## SYDNEY SOUTH PLANNING PANEL

Panel Reference	2016SYE051
DA Number	DA16/0388
LGA	Sutherland Shire
Proposed Development:	Staged development for concept master plan for construction of up to 23 residential flat buildings with infrastructure and a detailed design for construction of 6 residential flat buildings consisting of 131 dwellings
Street Address:	Lot 3 DP 31460, Lot 6 DP 31460, Lot 7 DP 31460, Lot P DP 413007, Lot 102 DP 868930, Lot 1 DP 31460, Lot 4 DP 31460, Lot 5 DP 31460, (Nos 103, 105-107, 109 & 113) Willarong Road, Caringbah
Applicant/Owner:	Caringbah Pty Ltd
Number of Submissions:	50 submissions
Regional Development Criteria (Schedule 4A of the Act)	The development has a capital investment value of more than \$20 million and as such is nominated under Schedule 4A (3) of the <i>Environmental Planning and Assessment Act 1979</i> .
List of all relevant s79C(1)(a) matters	<ul style="list-style-type: none"> <li>• State Environmental Planning Policy (State and Regional Development) 2011</li> <li>• State Environmental Planning Policy No. 65 – Design Quality of Residential Flat Development (SEPP 65)</li> <li>• State Environmental Planning Policy (Building Sustainability Index

'Master Plan' submitted as part of amendment E dated 31 March 2017

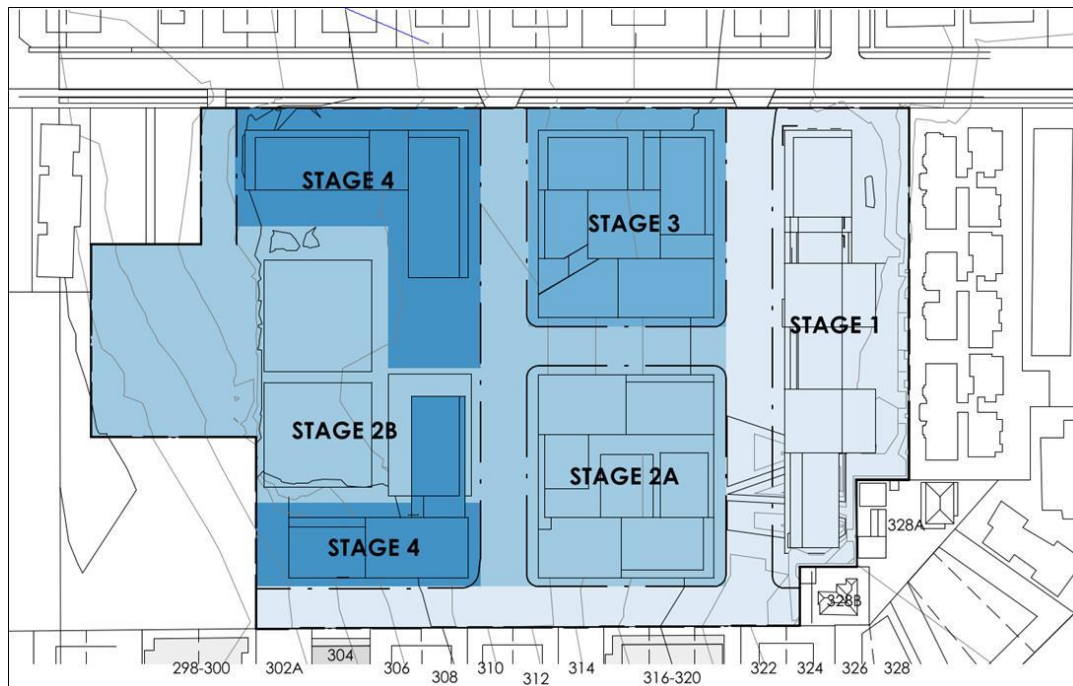
'Building Separation Diagram' submitted as part of amendment E dated 31 March 2017.  
 Note red highlighted differences identified by planning officer between the 'master plan'  
 and detailed design documents.

Specifically the following table highlights the difference in documentation:

Building	Master plan drawing 105	Building separation drawing 210
E1	8 storeys	7 storeys
H1	6 storeys	5 storeys
I2	No building I2 shown on plan	4 storeys
L	7 storeys	8 storeys
O	5 storeys	6 storeys

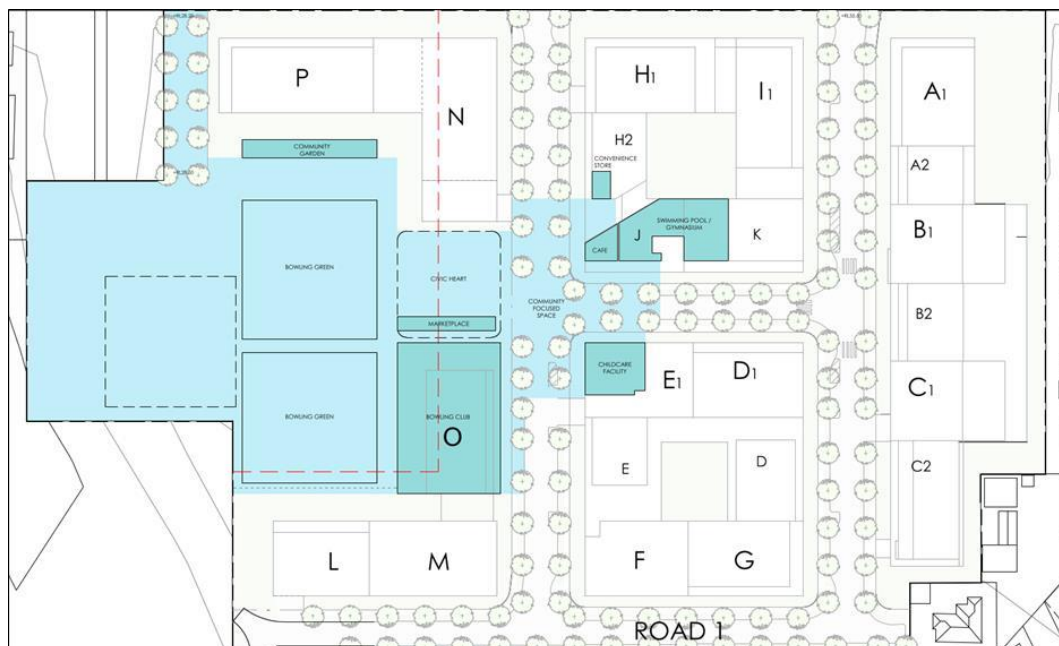
The proposed Stage 1 plan (extract above) shows Stage 1 to include buildings and works to the immediate frontage. The plan does not include either an access road to the proposed buildings or the north – south road which is inconsistent with the separate staging master plan provided as part of the master plan.
